**LEGAL ADVERTISEMENT
PORTLAND PLANNING BOARD MEETING**

To: Elizabeth Boepple, Chair, and Members of the Portland Planning Board
From: Shukria Wiar, Planner
Date: January 13, 2017
Re: 161 York Street
Project #: 2016-261 **CBL:** 044 B 006
Meeting Date: January 17, 2017

York Street Development LLC has requested a preliminary Level III site plan and subdivision review of an eleven-unit urban infill development at 161 York Street near the Casco Bay Bridge and State Street. The proposed 11,046 SF development includes a five-story multifamily building with parking at two different levels, as well as surface parking spaces. The site will be accessed from York Street and Guilford Court. The vacant lot was previously occupied by two 2-story residential buildings that have recently been demolished. The site is within the R-6 zone and within 100 feet of the West End Historic District.

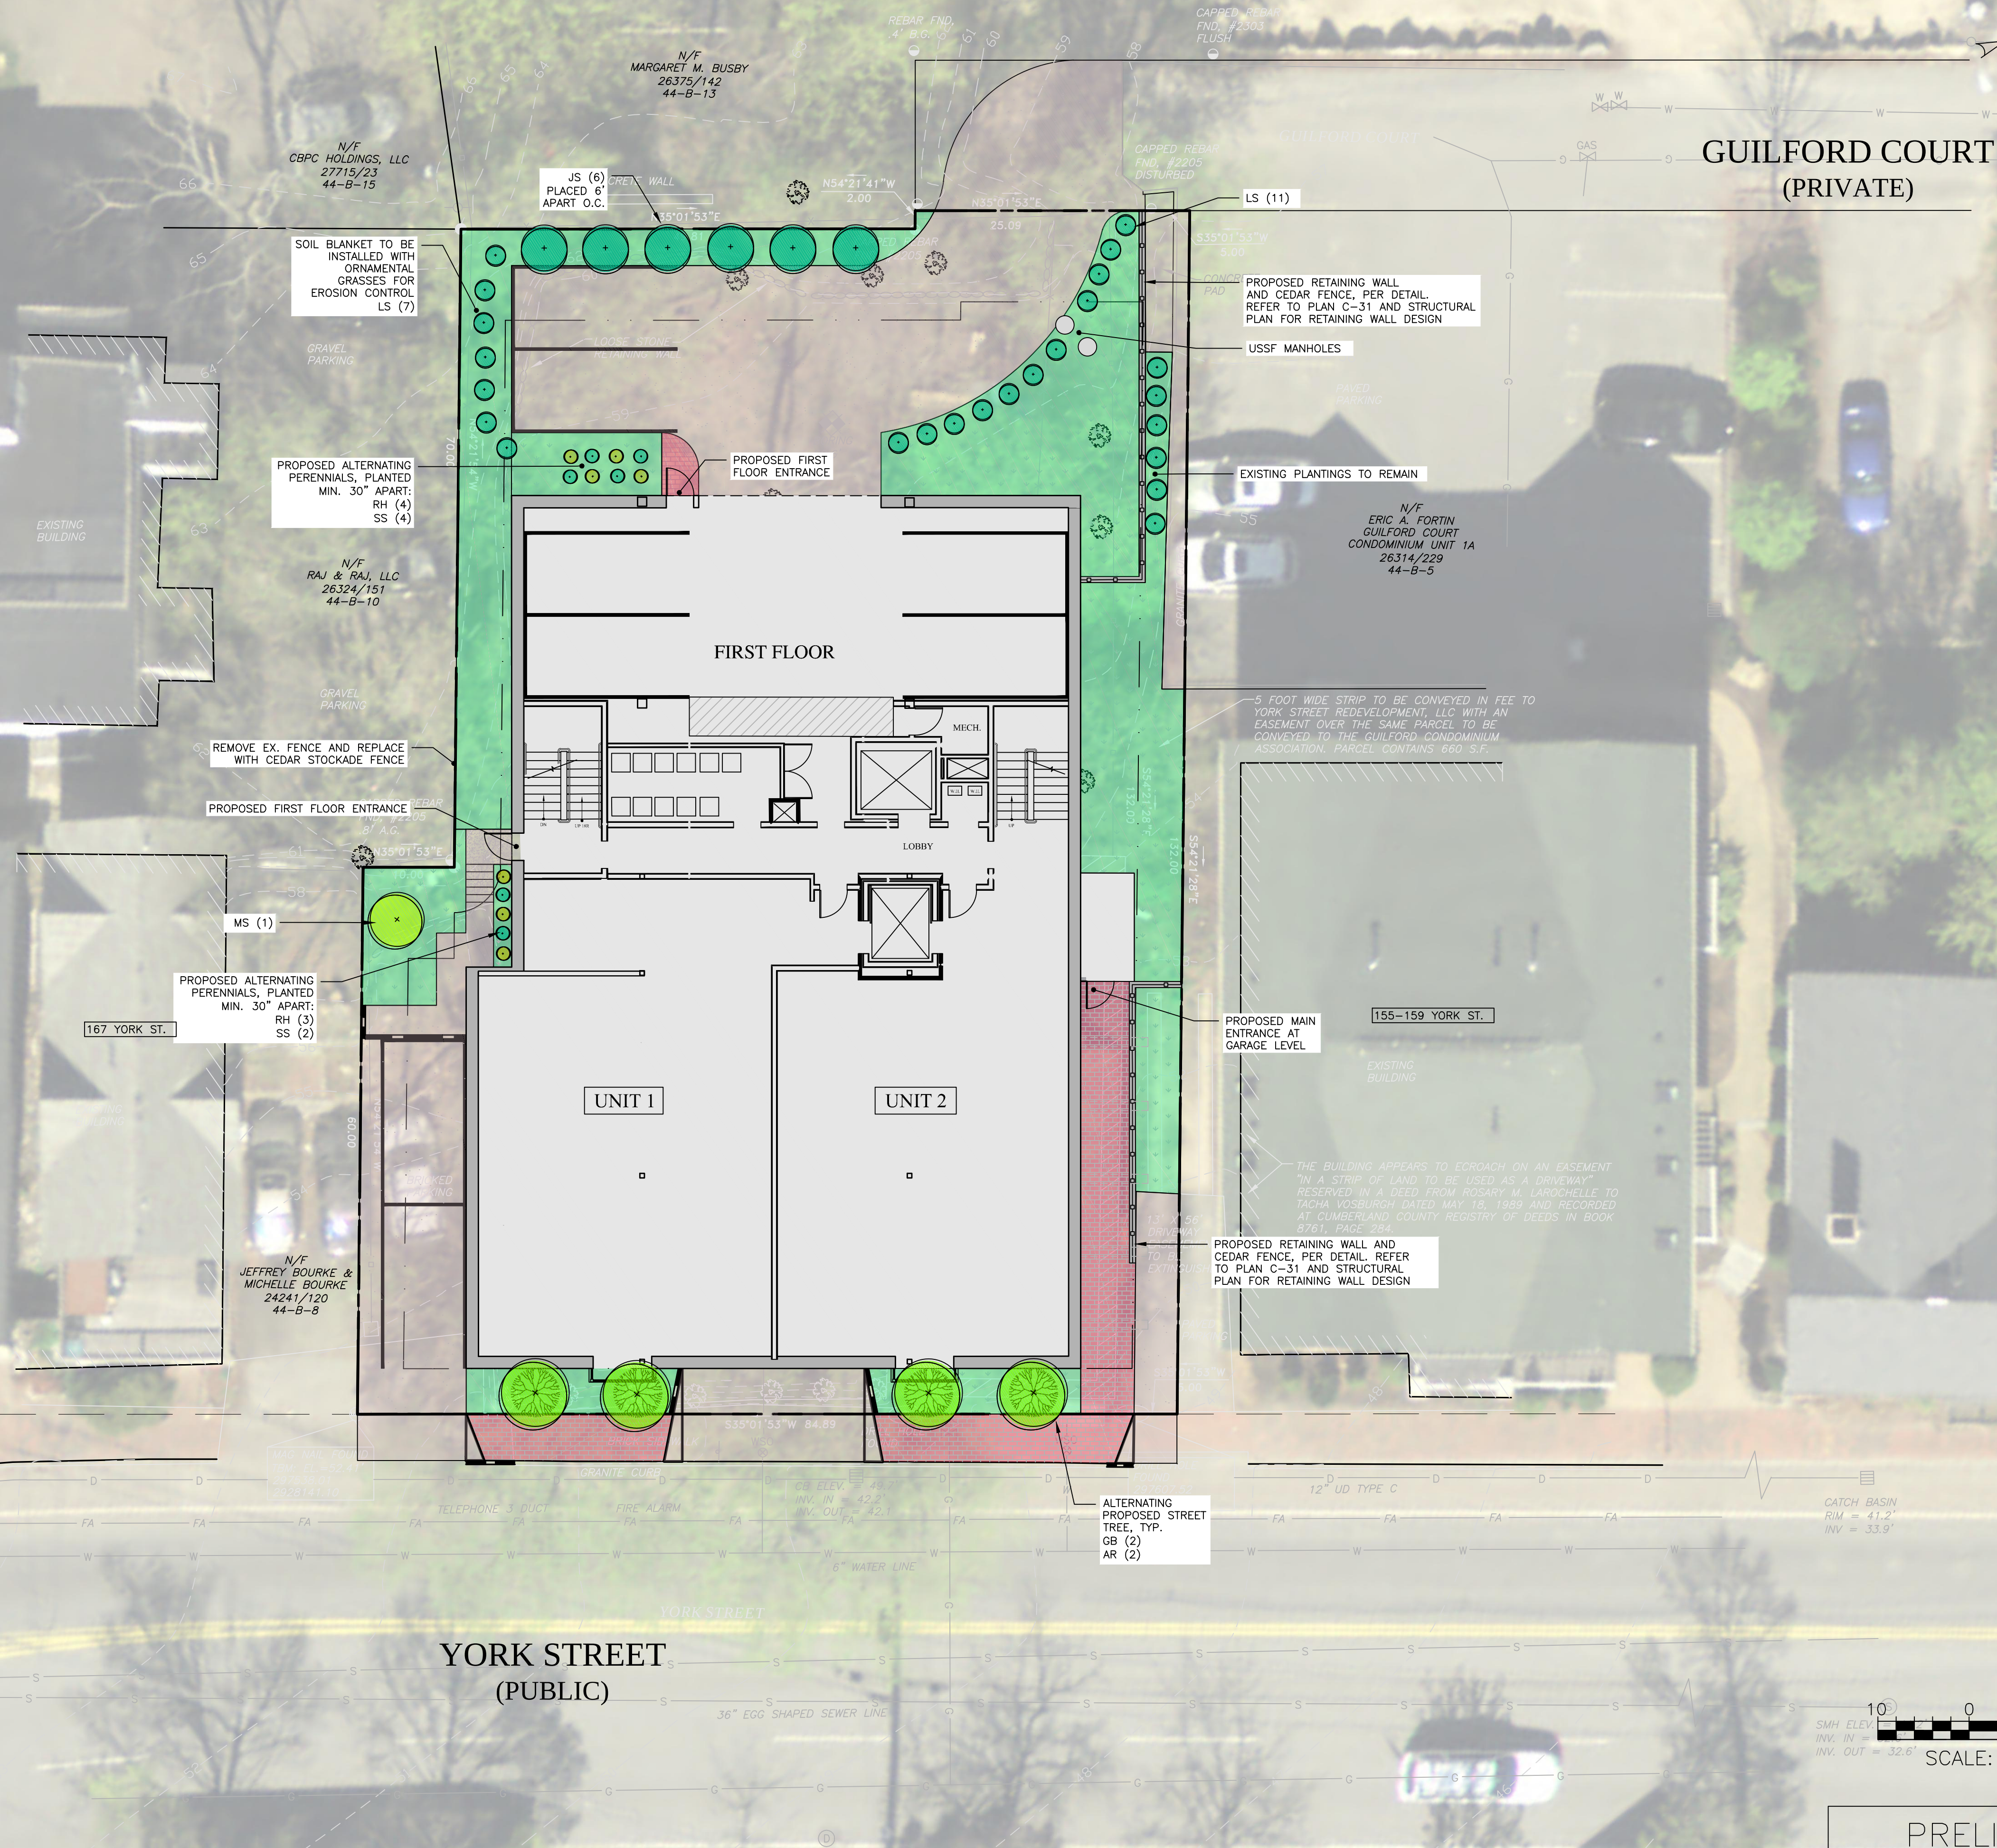
Comment: both species, upright Red Maple & Ginkgo should work well and fit into the overall streetscape. Options might be best from a streetscape view if all 4 trees are similar unless this is a design intent. Tree sizes shall meet city standards of 2-2.5" for all trees & plant material. The 3.25-GAL minimum listed in the landscape plan is too small for the Ginkgo as shown. The Landscape Plan 'Street view', recommendation is for additional landscape treatment in the tree planter along the back edge of curb between the sidewalk and foundation. This could include woody or herbaceous plantings, or groundcover planted in companion to the proposed 4 street trees.

b) Landscape - the project edges appear void of landscape treatment, unknown what is planned. Building shadows might suggest woody or herbaceous plants, or groundcover hardy to shade conditions.

Recommend revising / improving this section of landscape, the available green space while small for an 11-unit complex is important and should reflect landscape functions of screening to the extent possible and aesthetic interest for residents. Unknown if green infrastructure or rain gardens could be incorporated into the site plan.

c) Existing Plantings to remain - any tree / plant save areas should be protected during construction with adequate measures. Any plant loss to be replaced with agreed upon plant types to match.

DRAWING NO.	C-20
-------------	------

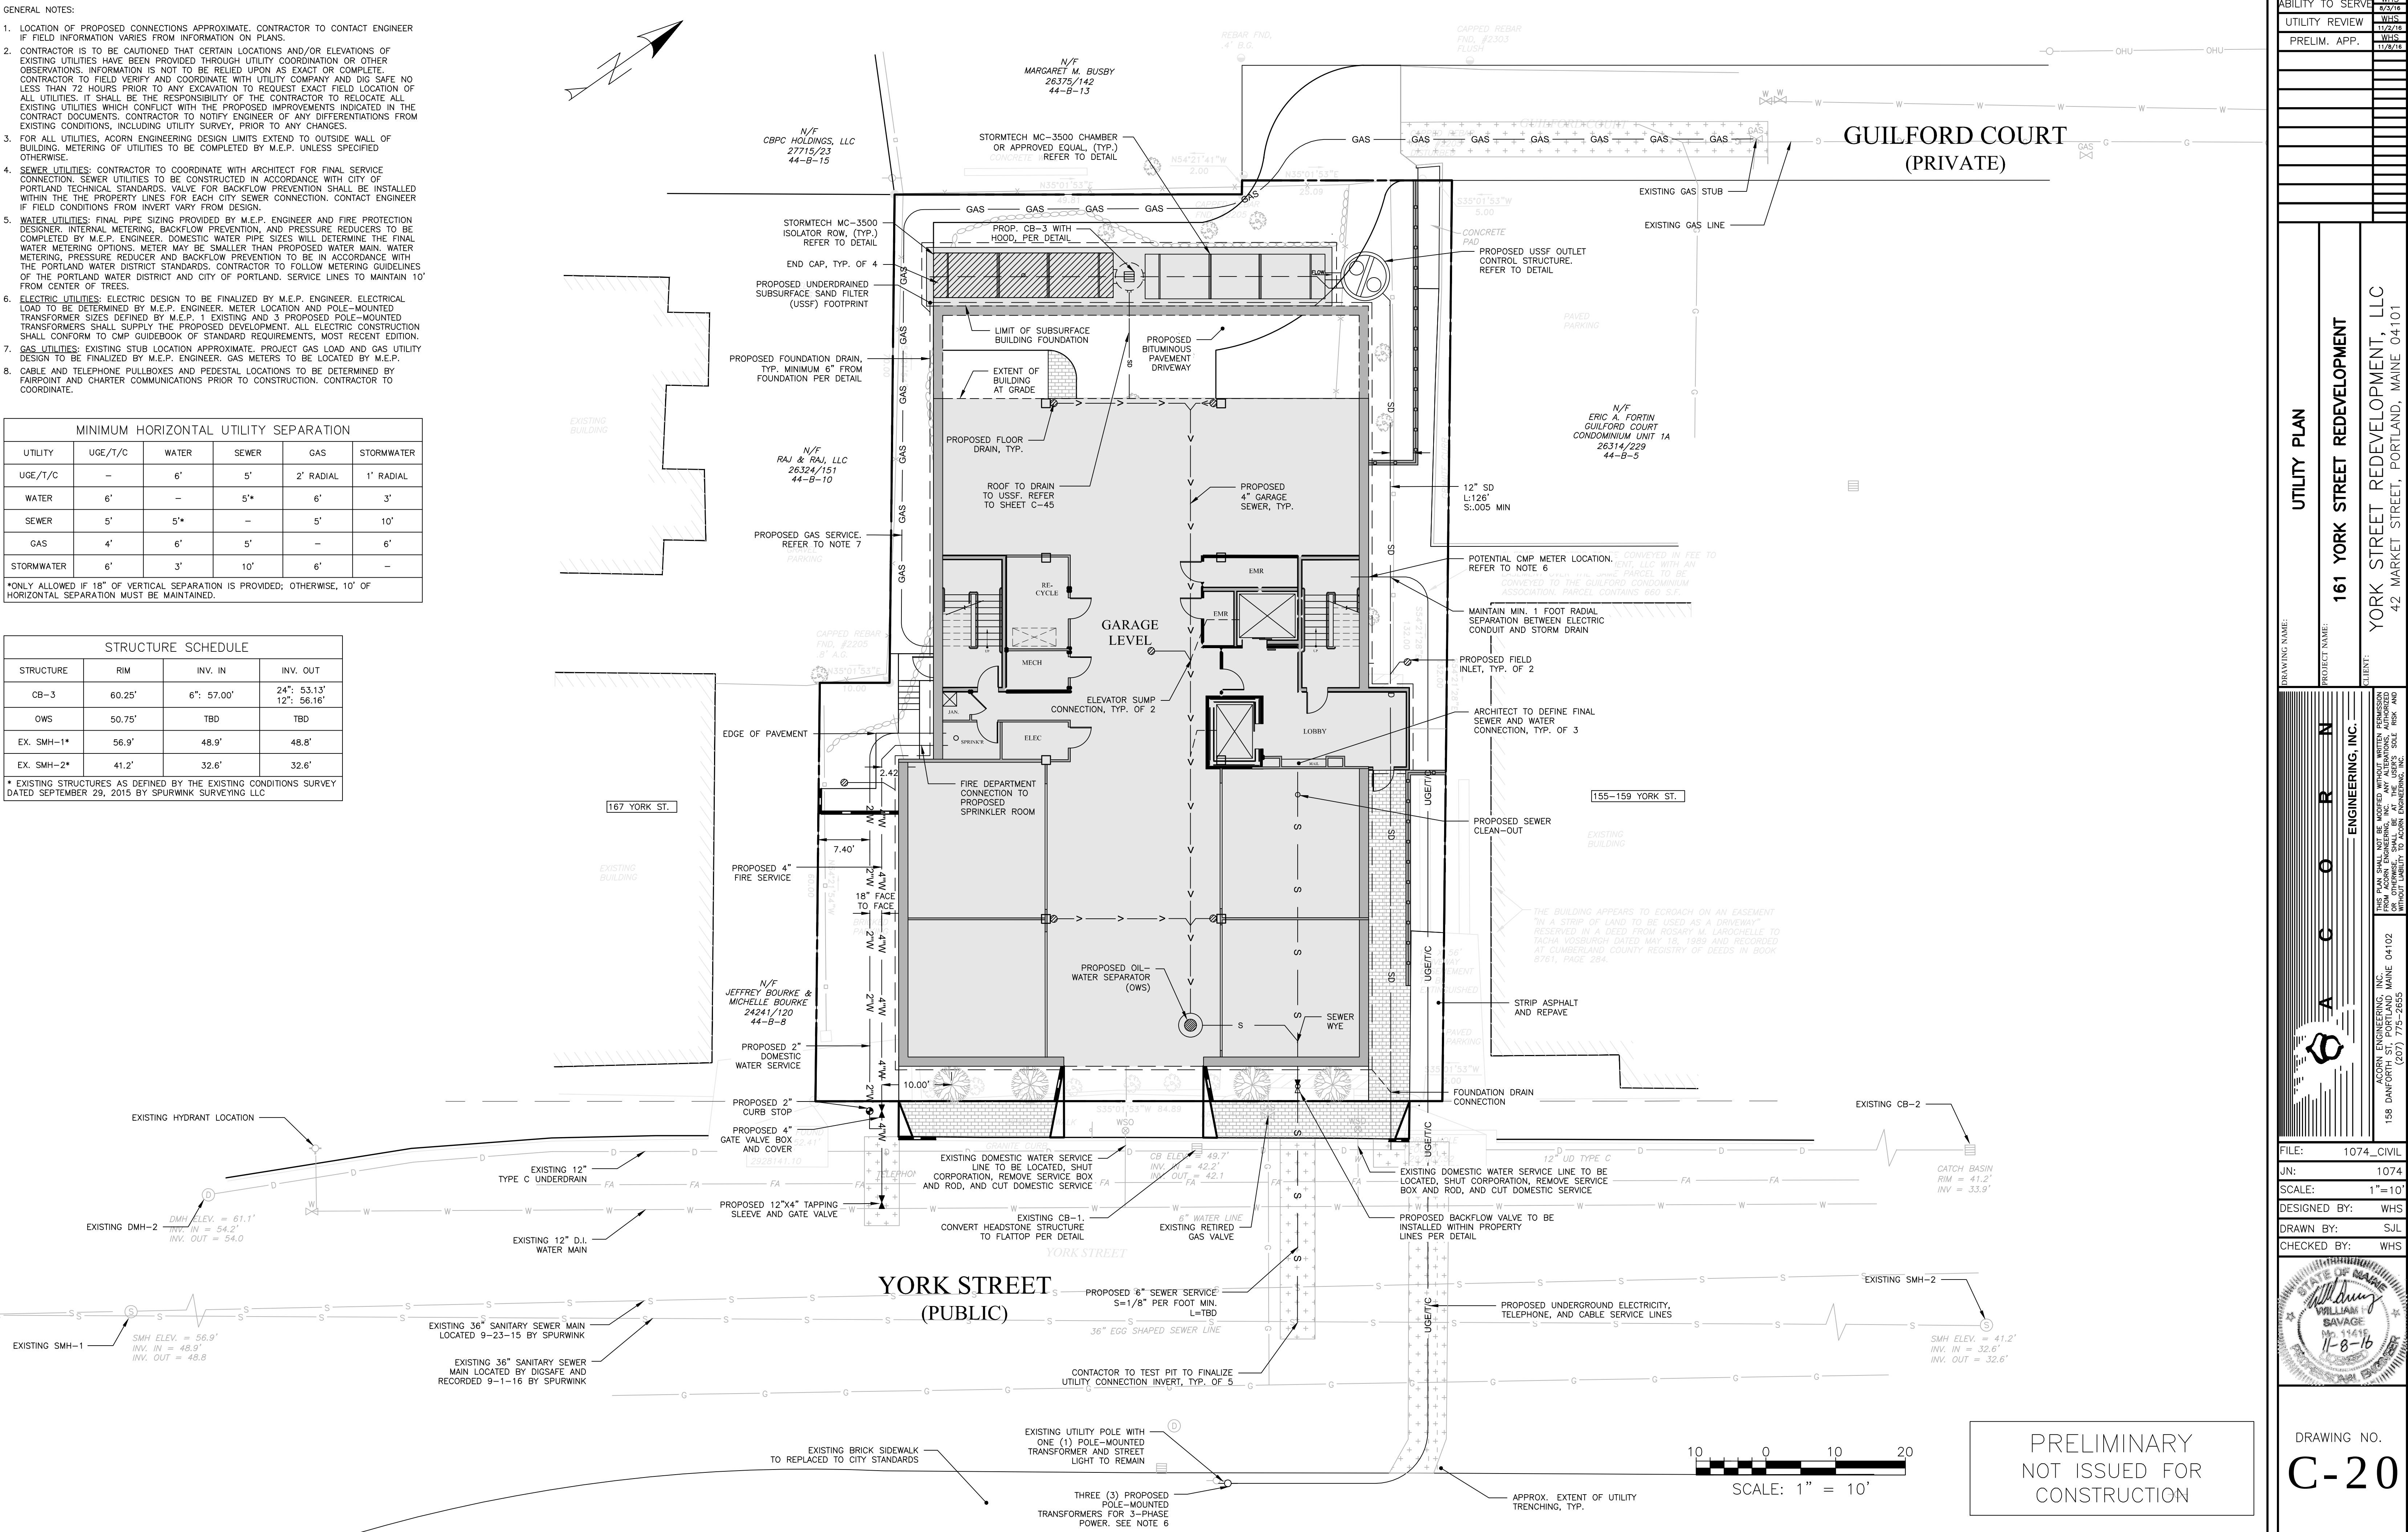
- A new 4-inch fire service and 2-inch domestic service may be installed as shown on the "Utility Plan, 161 York Street Redevelopment Sheet C-20 dated August 3, 2016 and returned to you with marked up comments.
- Two existing ¾" services SV271826 and SV273689 need to be terminated by shutting the corporation, cutting the copper and removing the curb box and rod.
- Once the final plans are approved and the project is ready for construction, the owner or contractor will need to make an appointment to come in and complete a service application form and pay the necessary fees.

STORM DRAIN AND SEWER TYPICAL TRENCH SECTION
NOT TO SCALE

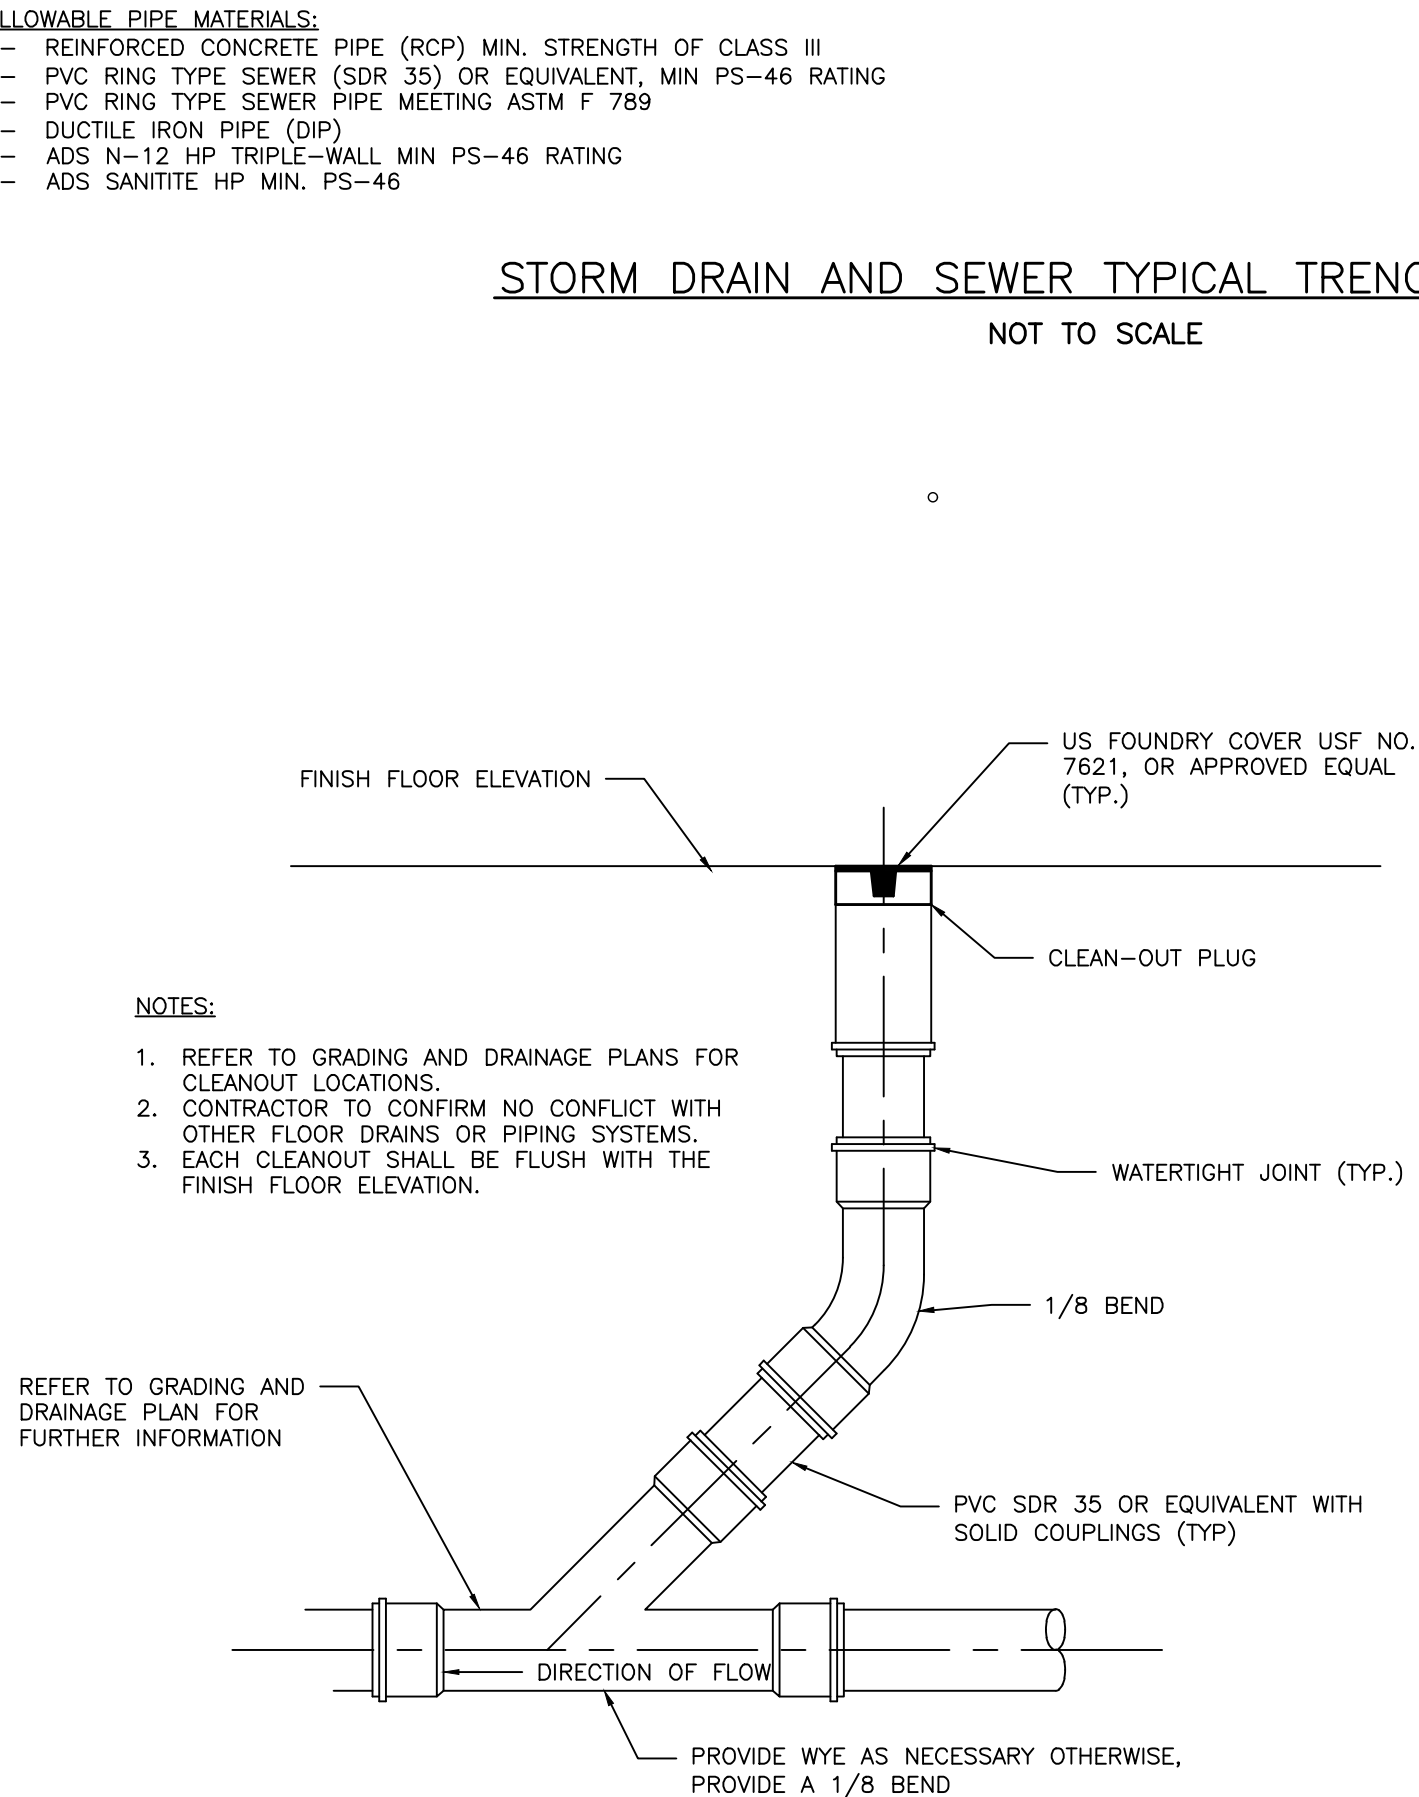
- *The City of Portland Typical Pipe Trench Detail should comply with the City of Portland Technical Manual.*
